**STAFF REPORT FOR CALENDAR ITEM NO.: 14
FOR THE MEETING OF: January 12, 2023**

TRANSBAY JOINT POWERS AUTHORITY

Adopt the Addendum (Addendum) to the Transbay Program 2018 Final Supplemental Environmental Impact Report (SEIR); adopt and incorporate into the Downtown Rail Extension (DTX) Project all of the revisions to four previously adopted mitigation measures as presented in the Addendum; adopt the Revised Mitigation Monitoring and Reporting Program under the California Environmental Quality Act (CEQA); and approve the Revised DTX Project analyzed therein.

Figure 2-8. Approved Fourth and Townsend Street Station Plan and Profile to be Modified

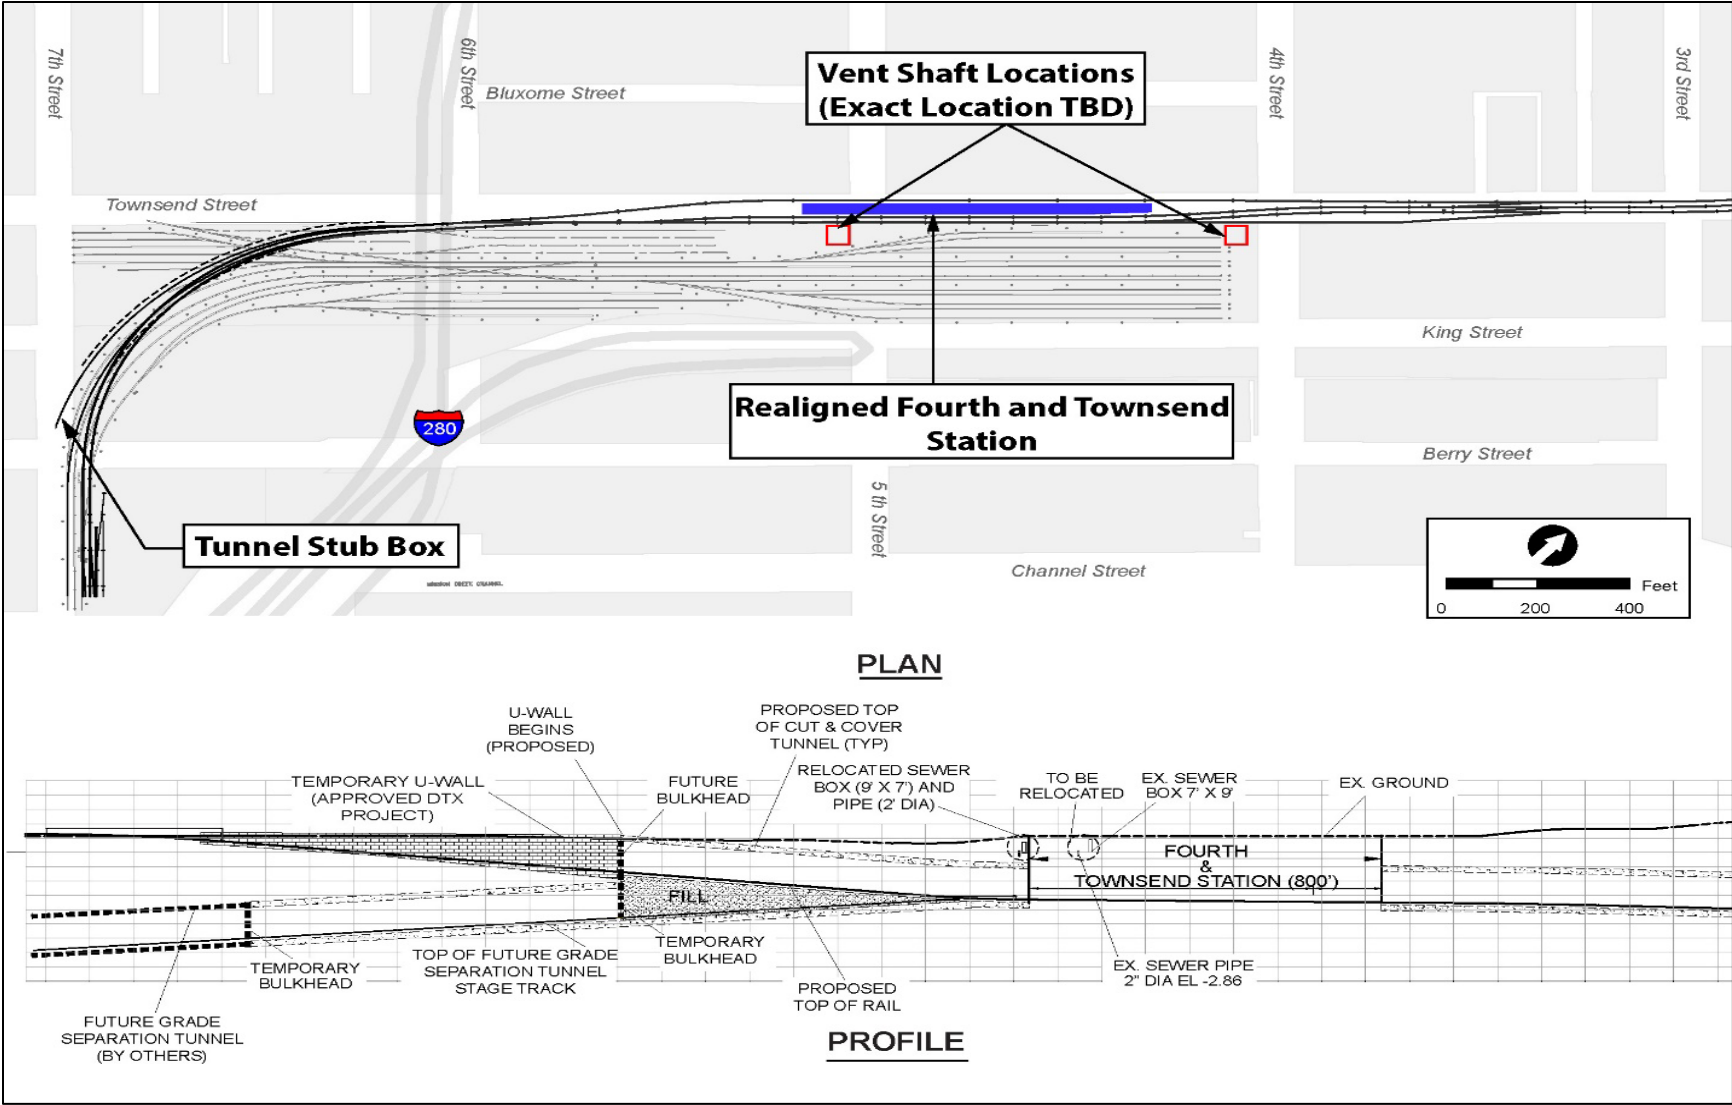
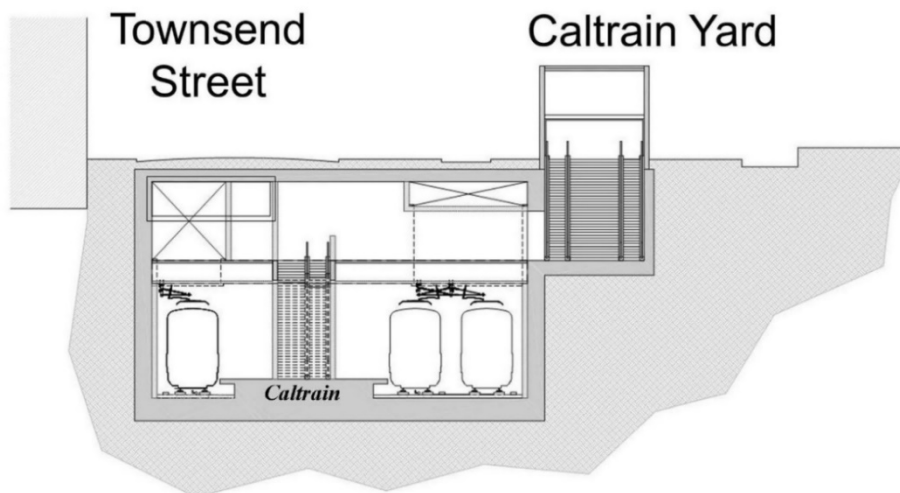
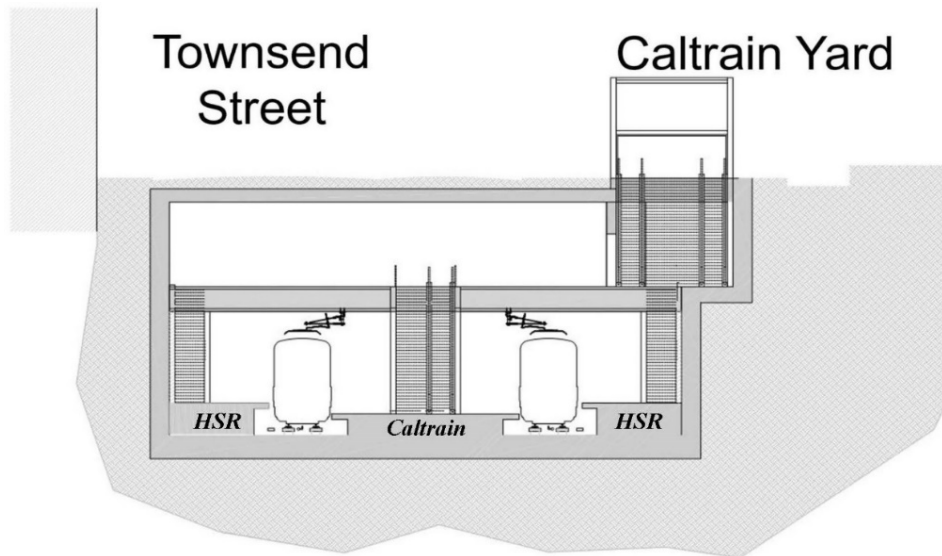
Approved Project. The approved project evaluated in the 2018 Final SEIS/EIR includes a realigned Fourth and Townsend Street Station. The underground station design at Fourth and Townsend Streets would be lowered and realigned along and underneath Townsend Street, a mezzanine would be added, and the tunnel would be lengthened. The realignment would shift the station slightly north from the previously approved DTX station plan and profile, which was oriented diagonally partially under the Caltrain railyard and partially under Townsend Street (Figure 2-8). The approved station includes Caltrain tracks on either side of a center platform and a passing track for CHSRA trains that would pass through the station without stopping (Figure 2-9).

Description and Objective of Proposed Revision. CHSRA has determined that high-speed trains would stop at the Fourth and Townsend Street Station (CHSRA 2020 and 2022a). The station layout and trackwork would be modified to include two tracks serving one center platform for Caltrain passengers and two side platforms serving CHSRA passengers (Figure 2-10). The modified Fourth and Townsend Street Station design would allow service for both Caltrain and CHSRA with dedicated platforms, eliminating conflicting inbound and outbound train movements in the throat section and enabling the reduced three-track segment in the tunnel as described above. To maintain Caltrain as the regional rail service and support high-speed rail (HSR) as the intercity rail service, HSR trains would disembark passengers at the Fourth and Townsend Street Station on northbound (inbound) trips toward the Transit Center, but would not pick up passengers at the Fourth and Townsend Street Station. Northbound Caltrain riders could transfer to a southbound HSR train at the Fourth and Townsend Street Station, but would remain on Caltrain if headed north (to the Transit Center). In the opposite, southbound (outbound) direction (away from the Transit Center), HSR trains would pick up passengers at the Fourth and Townsend Street Station, but passengers would not be able to disembark. The changes to the trackwork, the addition of platforms for HSR service, and the operational analysis were reviewed and endorsed by the Integrated Program Management Team.

The addition of the platforms for high-speed trains would widen the station box, compared to the approved station. Along the 1,000-foot-long southern perimeter of the station box, certain sections would encroach approximately 4 feet further while other sections would encroach 16 feet further into the Caltrain railyard, creating a more rectangular footprint than the approved station box. The approved station design was irregularly shaped along its southern limits with the Caltrain railyard because structures for vertical circulation (i.e., stairs, escalators, elevators) and vent structures extended beyond the station train box. With this proposed change, the resulting encroachment and land acquisition would be approximately 0.29 acre more than for the approved station. The sections that would encroach approximately 4 feet further into the Caltrain railyard would be for the vertical circulation and vent structures, as shown in Figure 2-11. The 2018 approved project acknowledged that the siting of the vent structures was “to be determined” and was only generally identified. The current plans identify the vent structure sites more precisely, and the resulting shift has been conservatively analyzed as 4 feet further south than previously evaluated in the 2018 Final SEIS/EIR. The vent structure at the eastern end of the station would also be sited further to the west within the revised station footprint. The modified Fourth and Townsend Street Station, which would widen the station approximately 16 feet and lower it 4 feet (at the west end) to 11 feet (at the east end), would require an additional 50,200 cubic yards of excavation and disposal of spoil material, compared to the approved project.

Figure 2-12. Proposed Realigned Tunnel Stub Box

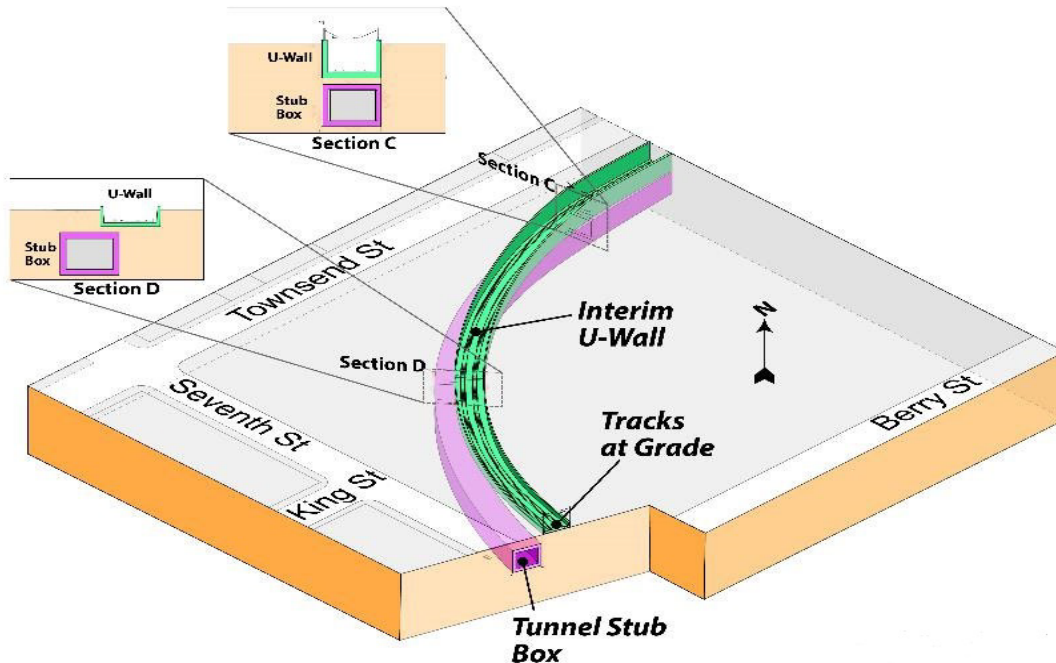
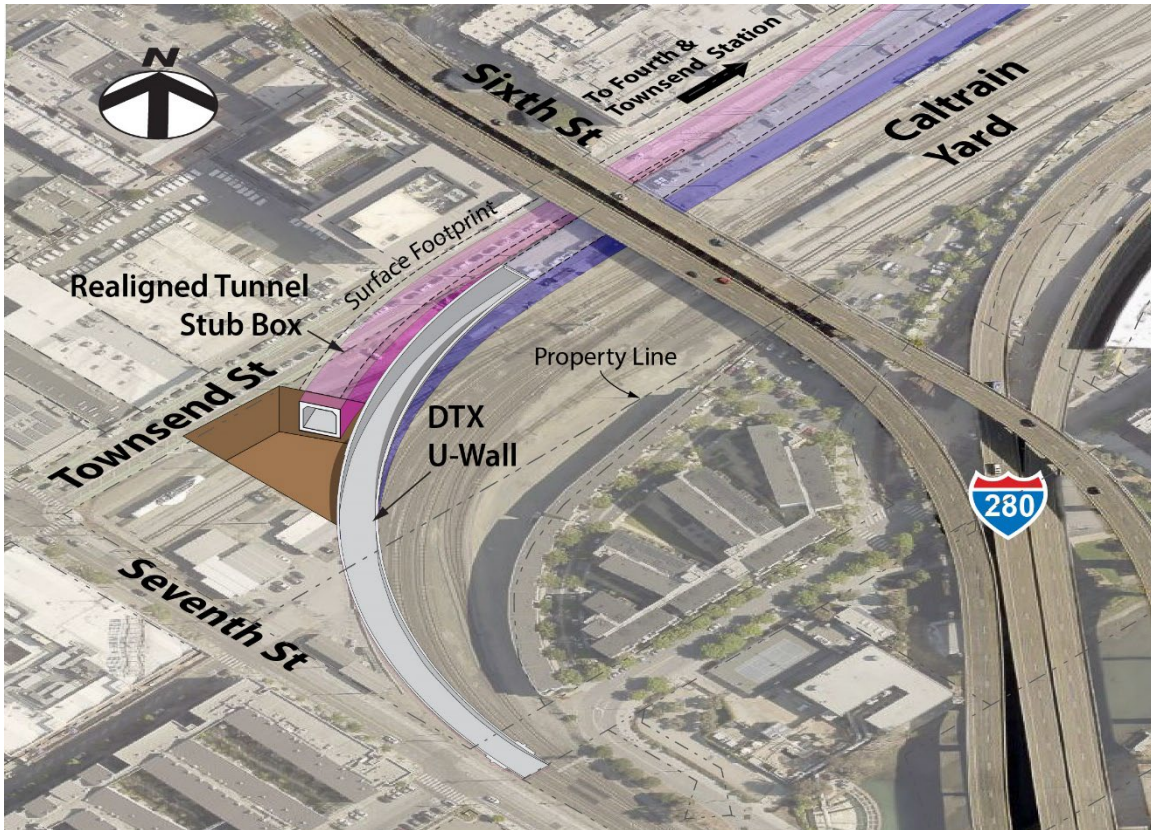
Approved Project. The approved project evaluated in the 2018 Final SEIS/EIR includes a below-grade train box segment (referred to as the tunnel stub box) at the west end of the Caltrain railyard beneath the previously approved interim U-wall. The purpose of the tunnel stub box is to expedite future below-grade Caltrain and HSR service (i.e., the transition between the existing at-grade tracks south of the railyard and the below-grade Fourth and Townsend Street Station), and to preserve future options regarding grade separations. The tunnel stub box that was evaluated in the 2018 Final SEIS/EIR and

approved would be south of Townsend Street between Sixth and Seventh Streets within the Caltrain railyard. The underground construction for the tunnel stub box described in the 2018 Final SEIS/EIR is shown in magenta in Figure 2-11. In the future, when an underground tunnel is constructed to avoid at-grade crossings between the mainline tracks and surface streets south of the Caltrain railyard (which is a separate project under study by the San Francisco County Transportation Authority, and is not part of the DTX project), the interim U-wall portion could be demolished and the tunnel stub box could be outfitted with tracks, systems, and other required elements.

Description and Objective of Proposed Revision. In furthering design of the Fourth and Townsend Street Station and analyzing the operational impacts of the future grade separation tunnel, the tunnel stub box alignment has been refined. The modifications would alter its alignment so that it would be shorter, adjacent to the U-wall rather than underneath it, and partially underneath the Townsend Street right-of-way. The tunnel stub box would be underneath one-half of the width of Townsend Street between Fifth and Sixth Streets and underneath one traffic lane of Townsend Street between Sixth and Seventh Streets, for a total length of approximately 1,000 feet. Only the south side of Townsend Street adjacent to the Caltrain railyard would be affected by the realigned tunnel stub box (stub box shown in pink in Figure 2-12). During the cut-and-cover construction of the tunnel stub box, street-level decking would be laid on Townsend Street, to allow continued vehicular access. No modifications to the U-wall would be required to realign the tunnel stub box.

The proposed realignment of the tunnel stub box to be adjacent to the U-wall would enable both to be used at the same time. The U-wall would be available for trains to move from the railyard into the tunnel, and the tunnel stub box would provide access into the tunnel by a future underground connection for Caltrain and high-speed rail. The rationale for constructing the tunnel stub as part of the Revised Project is the same as presented in the 2018 Final SEIS/EIR; which is to support the future arrival of below-grade Caltrain and HSR service, and to preserve future options regarding grade separations. The proposed alignment would require less excavation than the approved project because of the shallower tunnel stub box. In addition, the proposed alignment of the U-wall and tunnel stub box would allow Caltrain service and movements between the railyard and the tunnel to continue with minimal disruption when the future underground connection is constructed through the western portion of the Caltrain railyard.

**Figure 2-14. Proposed Reconfiguration of At-Grade Trackwork
at Mission Bay Drive**

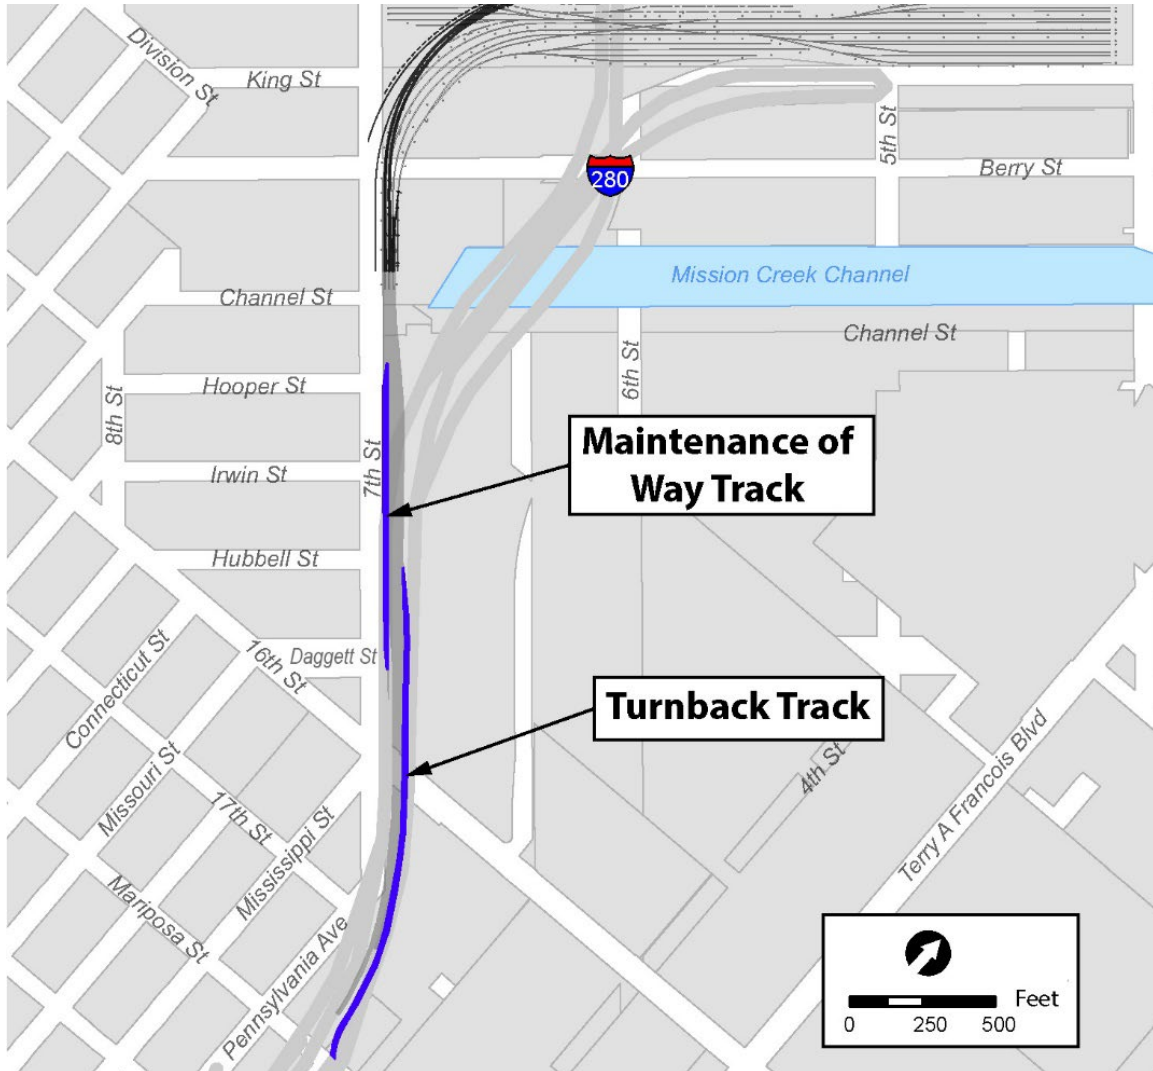
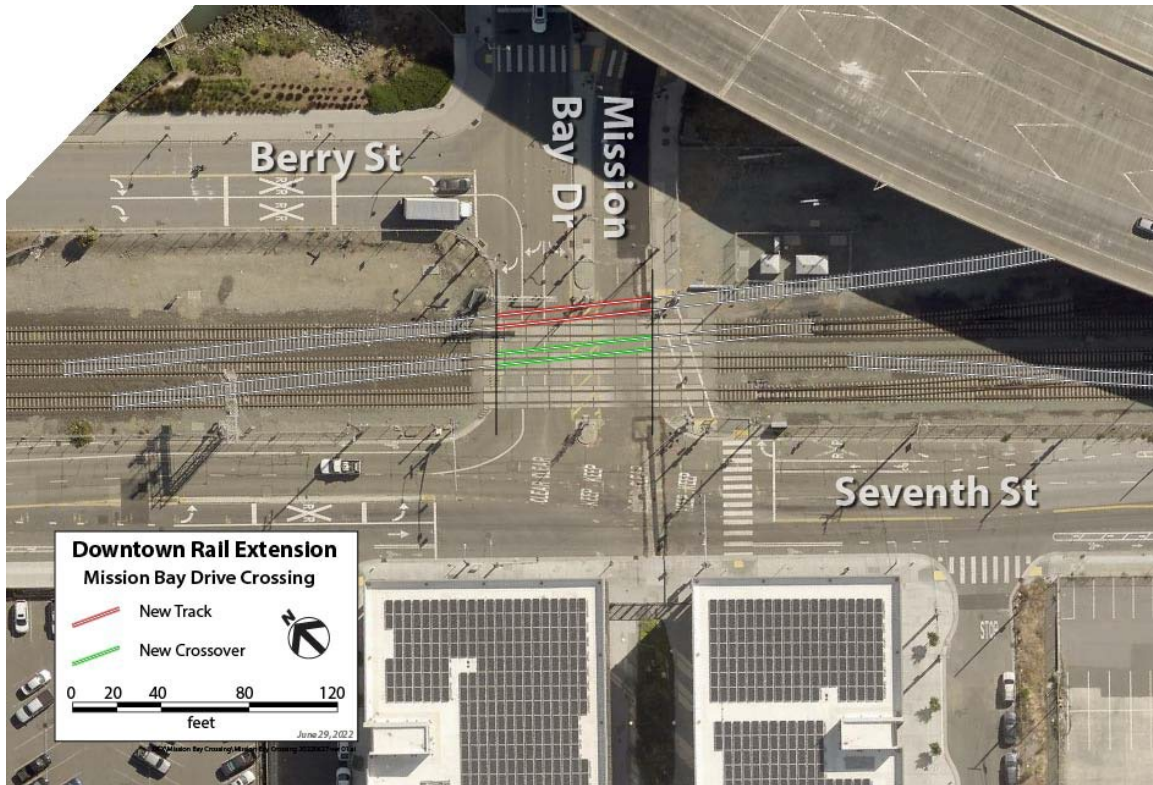
Approved Project. The approved project evaluated in the 2018 Final SEIS/EIR includes an at-grade turnback track on the east side of the existing mainline tracks within the Caltrain right-of-way, from Hubbell Street on the north, extending southward for approximately 1,400 feet under the elevated I-280 freeway across 16th Street, and terminating at Mariposa Street (Figure 2-13). Caltrain trains from the Caltrain railyard would travel south along the track lead, onto the mainline track, and onto the turnback track at Hubbell Street.

Trains would continue south along the turnback track, crossing 16th Street at-grade, until Mariposa Street. Trains then would proceed north, back along the turnback track, and would transition onto the mainline heading toward the Transit Center. The same movements would be followed in reverse to move trains from the Transit Center to the Caltrain railyard. The approved turnback track would cross 16th Street at grade, but would not cross Mission Bay Drive to the north or Mariposa Street to the south.

Description and Objective of Proposed Revision. In furthering the design of the at-grade trackwork south of the Caltrain railyard, the TJPA and Caltrain have agreed that relocating the MOW track from the west side of the mainline tracks to the east side, where

it would connect and run parallel to the turnback track, would allow more efficient train movement between the railyard and the Transit Center. This reconfiguration would include an additional track at the existing at-grade crossing of Mission Bay Drive within the Caltrain right-of-way (the red-colored track in Figure 2-14), resulting in four tracks at this crossing compared to the three existing Caltrain tracks. The additional, fourth track could be used to access either the MOW or turnback track. It would be at a slight angle (further from the other tracks at the south end) and would require moving the east side railroad crossing gate further east along Mission Bay Drive by approximately 9 feet. To facilitate train operations, a new crossover track also would be added between the existing tracks at the Mission Bay Drive crossing (the green-colored track in Figure 2-14). A crossover track is a special trackwork element that allows trains to move from one track to another as directed by the central train control dispatch and the signaling system. The westbound Mission Bay Drive vehicle signal stop line is east of Berry Street; signal timing along Mission Bay Drive at Berry Street is interconnected with the timing at Seventh Street and allows vehicle clearance on the track. The red-colored track (see Figure 2-14) would connect to two existing, MOW tracks on the east side of the Caltrain right-of-way that would be upgraded for use as a MOW or turnback track.

Trains would continue to use the existing tracks at the Mission Bay Drive grade crossing for routine revenue service, while use of the additional MOW/turnback track would occur only during off-peak hours. Caltrain is working to identify the number of off-peak movements for the additional track at Mission Bay Drive based on the Caltrain Business Plan.

Figure 2-15. Proposed Reconfiguration of At-Grade Trackwork South of the Caltrain Railyard

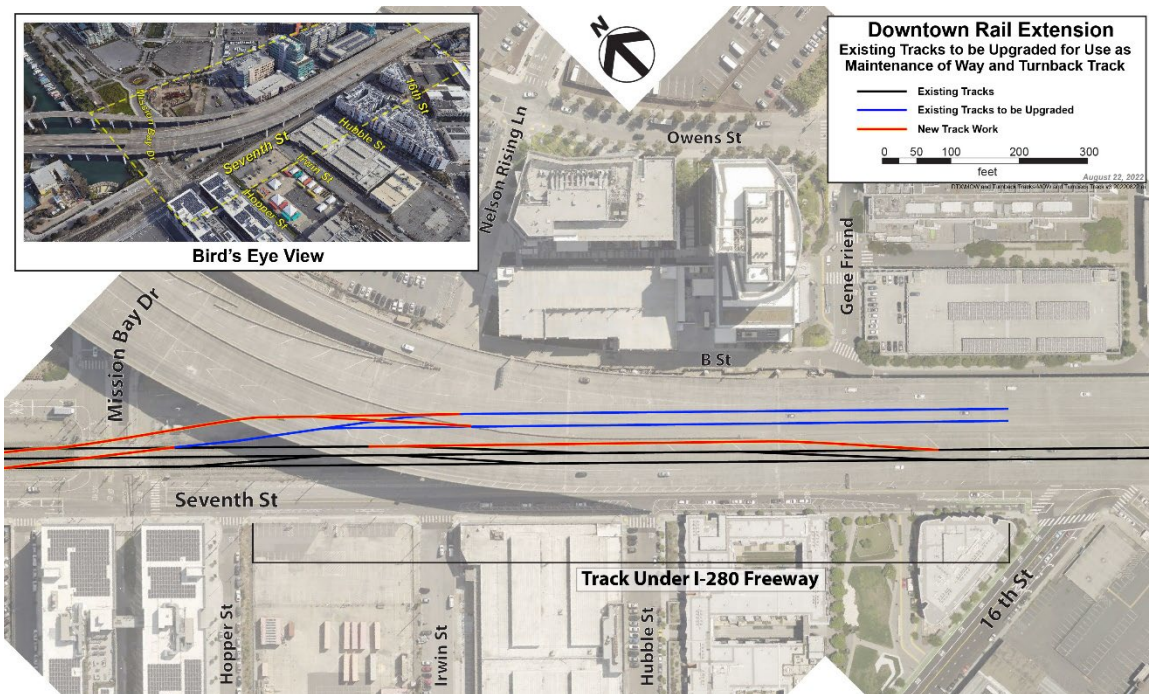
In addition to the changes to the trackwork at Mission Bay Drive, another new track within the Caltrain right-of-way between existing tracks, from approximately just north of Irwin Street to just north of 16th Street, would be constructed to provide operational flexibility. This project modification was developed by TJPA in collaboration with Caltrain, and would, in conjunction with the additional track at Mission Bay Drive, eliminate the need for the turnback track to extend across 16th Street and continue to Mariposa Street. Figure 2-15 shows this new track, as well as the new track across Mission Bay Drive described above.
